**Proposed Public Utility Installation (Overhead Line, Pole and Pole Stay Erection) and Excavation and Filling of land
(Application No. A/NE-LT/767)**

**Proposed Public Utility Installation (Underground Cable Laying, Overhead Line, Pole and Pole Stay Erection) and Excavation and Filling of land
(Application No. A/NE-LT/768)**

**Proposed Public Utility Installation (Underground Cable Laying and Pole Erection) and Excavation and Filling of land
(Application No. A/NE-LT/769)**

Comments from Sha Tin, Tai Po & North District Planning Office, Planning Department
[Contact person: Mr. Benson LAU (Tel: 2158 6225)]

Location Plan 03

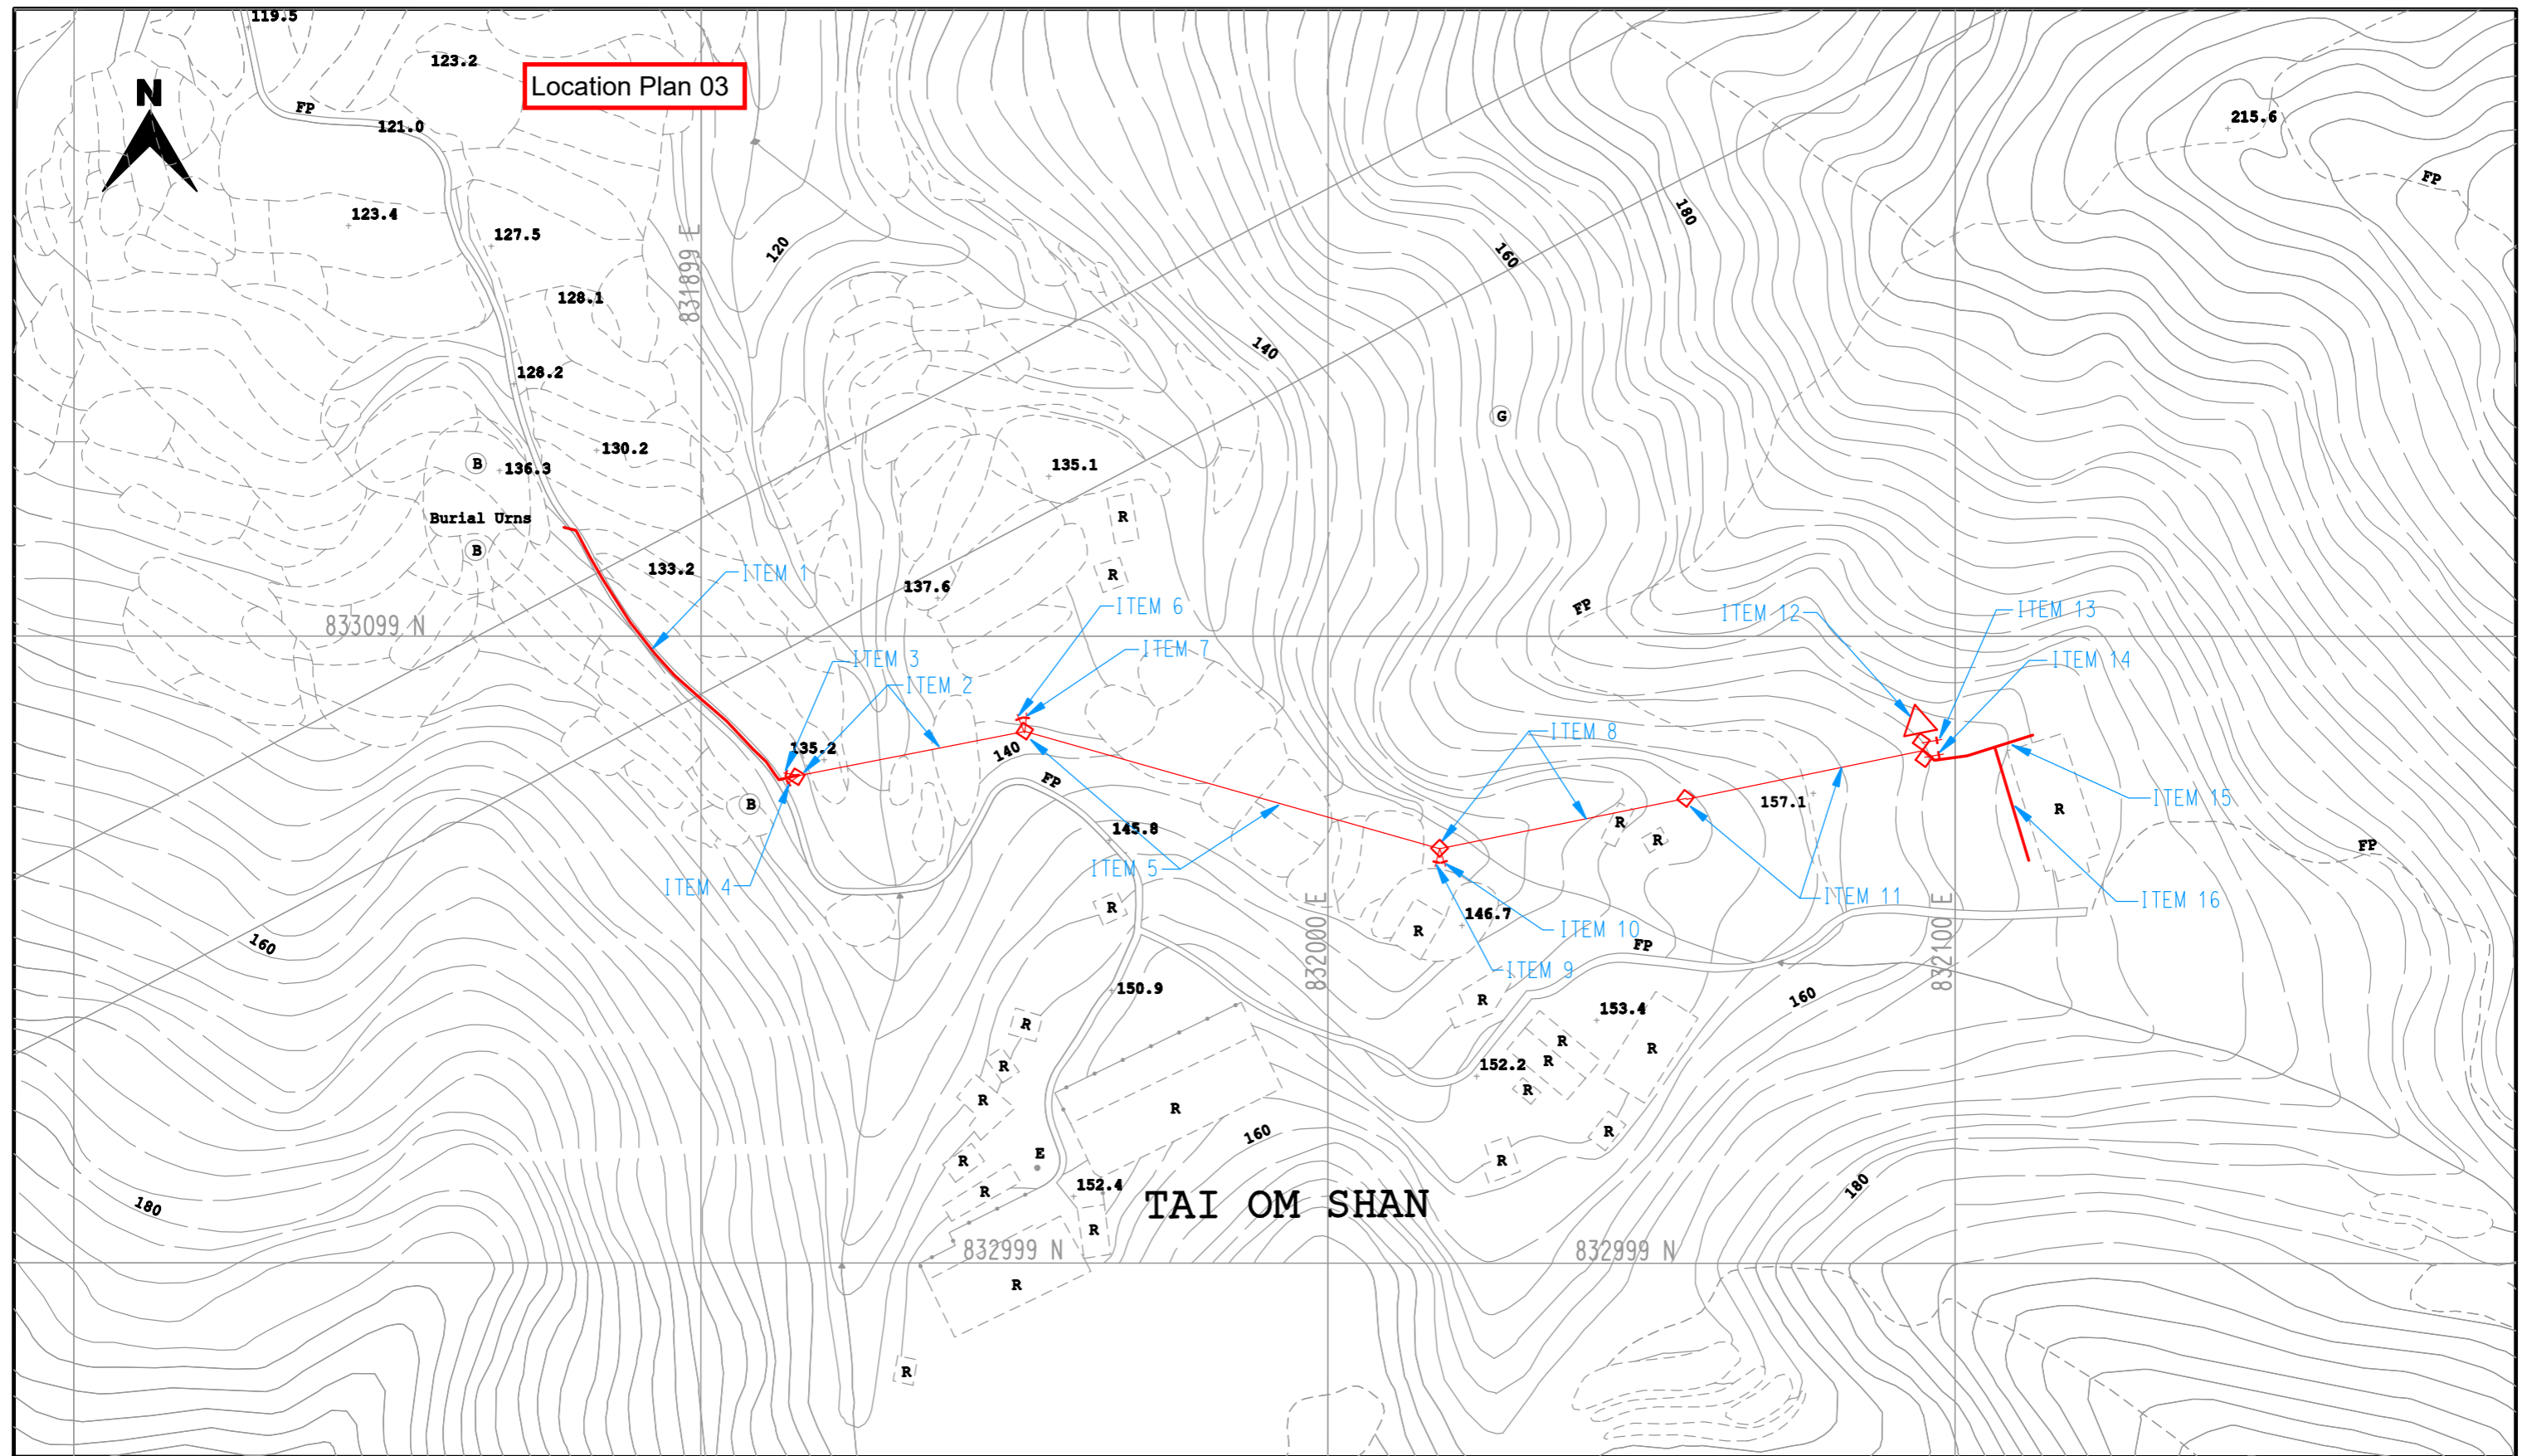
8. According to the application form, the site area is 65.5 sq.m which comprises area for cable laying (40 sq.m), OHL pole erection (3 nos. of 2m x 2m = 12 sq.m), and pole stay erection (6 nos. of 1.5m x 1.5m = 13.5 sq.m). With reference to the drawing titled "Location Plan 03", it appears that the area indicated for cable laying is about 55 sq.m (about +40% as compared to the application form). Please review the area for cable laying and update the relevant figures in the application form and drawings where appropriate.

~Please refer to updated attachment "Form No. S.16-I_Nov 2023_NRSS2022-0390-03TH_R3 Revised pages".

Outline Zoning Plan (OZP) 03

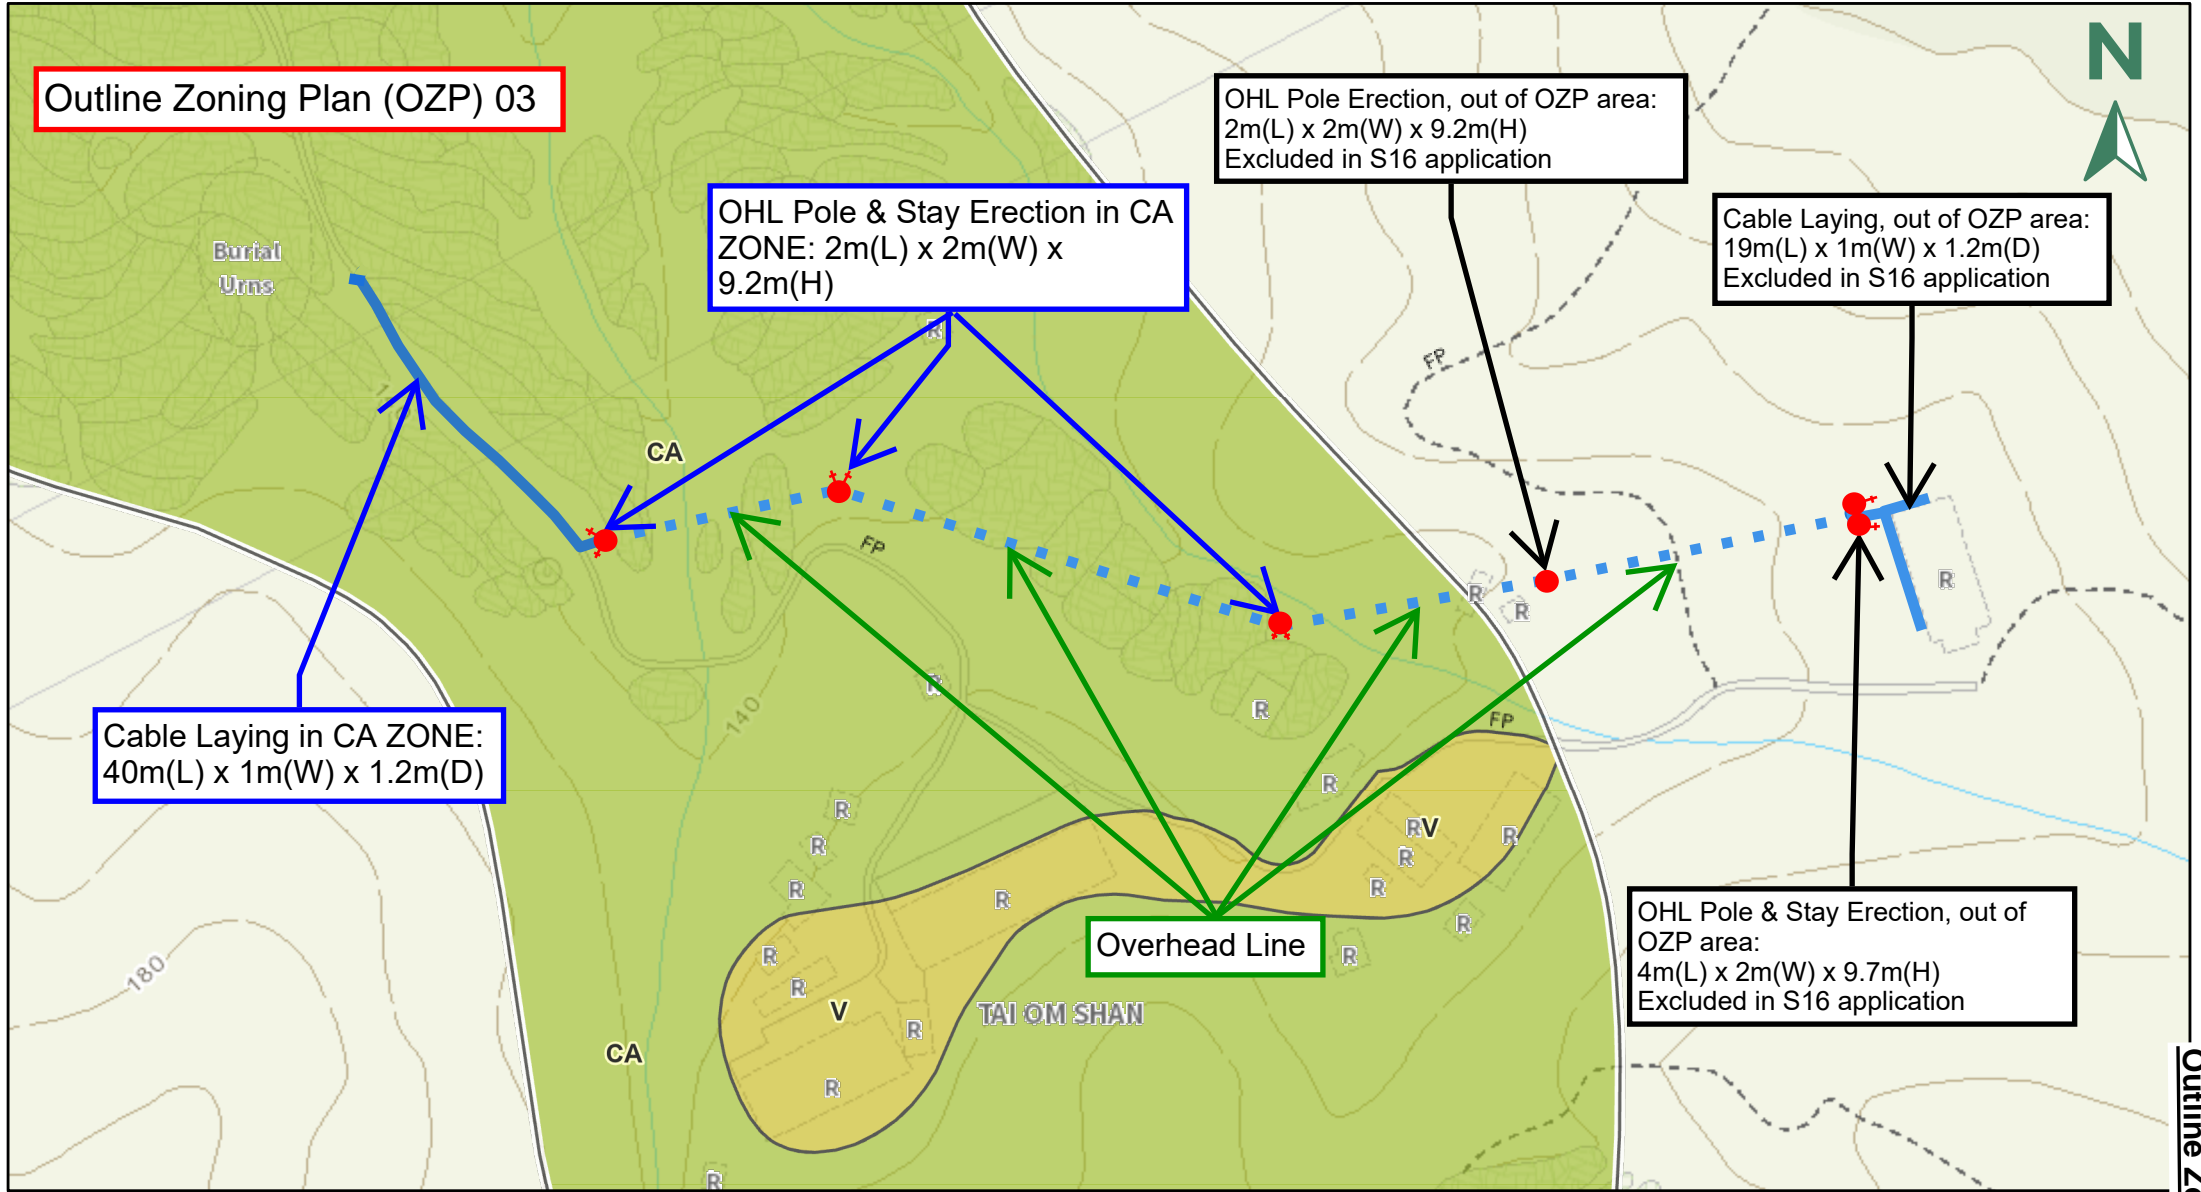
9. For clarity, please indicate on the drawing titled "Outline Zoning Plan (OZP) 03_R" that the OHL pole erection and cable laying which fall outside the OZP do not form part of the subject planning application. Amended.

10. According to the application form, the height of the OHL pole erection is 9.2m, which is slightly different to that as stated in drawings titled "Outline Zoning Plan (OZP) 03_R" and "Pole Section Drawing 01" (i.e. 9.1m). Also, please indicate the location of pole stay erection on the drawing titled "Outline Zoning Plan (OZP) 03_R" for consistency.

~Please refer to updated attachment "Outline Zoning Plan (OZP) 03_R2".

~Drawing amended.

TITLE :
**11kV OHL WOOD POLE CONSTRUCTION
ANGLE SECTION POLE**

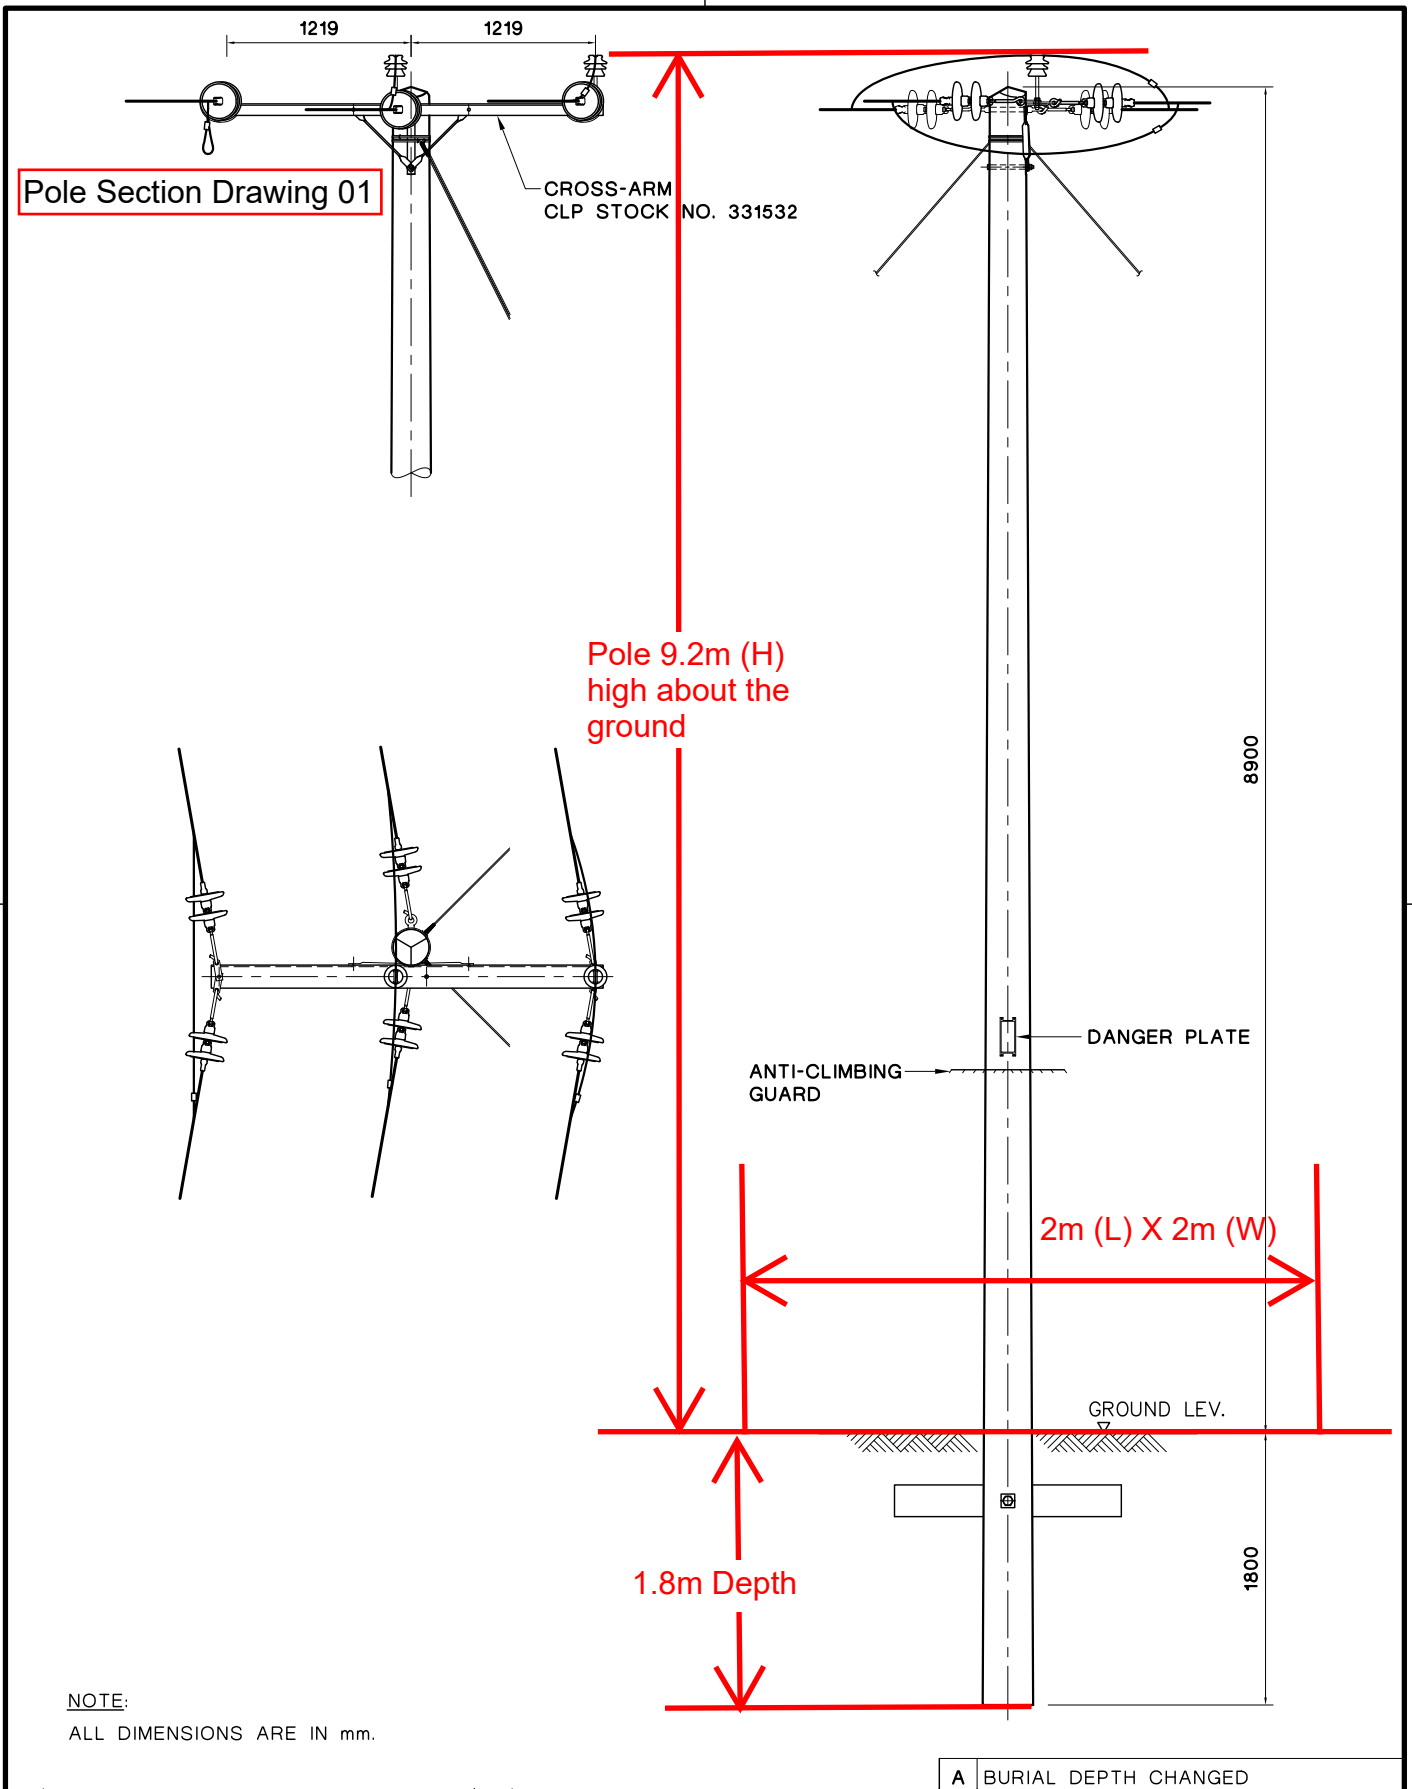
6. According to the application form, the height of the OHL pole erection is 9.2m, which is slightly different to that as indicated on drawings titled "Outline Zoning Plan (OZP) 02_R" and "Pole Section Drawing 01" (i.e. 9.1m). Also, please indicate the location of pole stay erection on the drawing titled "Outline Zoning Plan (OZP) 02_R" for consistency.

~Drawing amended.

~Please refer to attachment "Pole Section Drawing 01_R".

Sectional Plan_HV

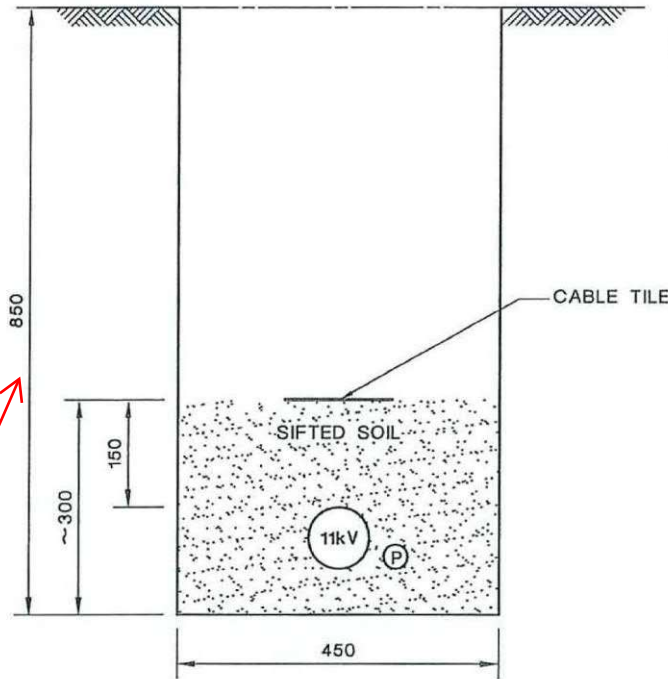
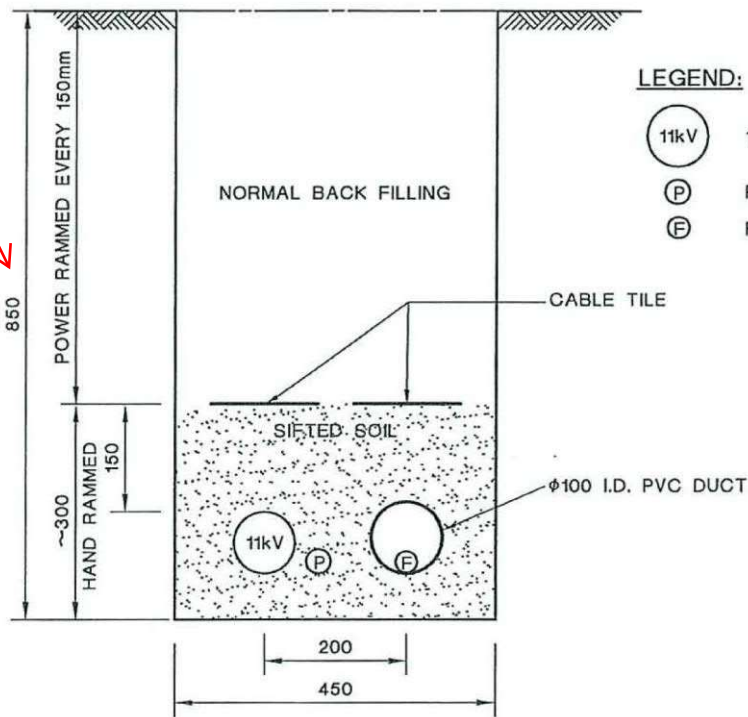
11. Please indicate the excavation depth of 1.2m for cable laying on the drawing titled "Sectional Plan_HV" as stated in part 6 (iii) for reference.

13. Please indicate the excavation depth of 1.2m for cable laying on the drawing titled “Sectional Plan_HV” as stated in part 6 (iii) for reference.

~Drawing amended.

~Drawing amended.

~Please refer to attachment “Sectional Plan_HV_R”.
